Re: Work Session for The Twenty Ones – Design Review & Special Exception
Petitions PLNPCM2019-01170 & PLNPCM2020-00200

THE TWENTY ONES – DESIGN REVIEW & SPECIAL EXCEPTION

Property Address: Approximately 2105 East 2100 South

Figure 2: Site Plan

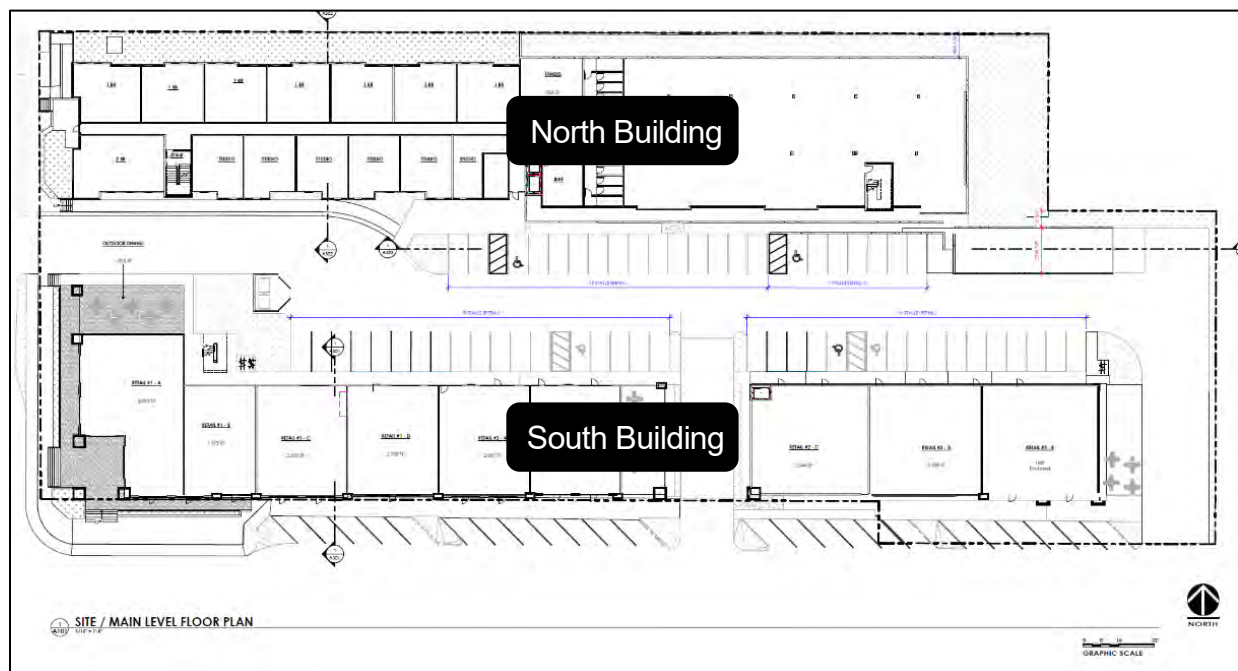
As mentioned above, Planning Staff's primary reservation is the design of the 2100 South façade, including the streetscape, and whether it meets the CB zone, Design Review standards and the 21st and 21st Neighborhood Plan. Although the CB zone does not have a design standard related to the maximum length of a street-facing façade, the 21st and 21st Neighborhood Plan provides guidance, stating that the length of a street-facing façade should not be longer than 150 feet. Given that the façade is significantly longer than 150 feet, at approximately 400 feet, staff believes that the current design may not meet the intent of the ordinance or neighborhood plan.
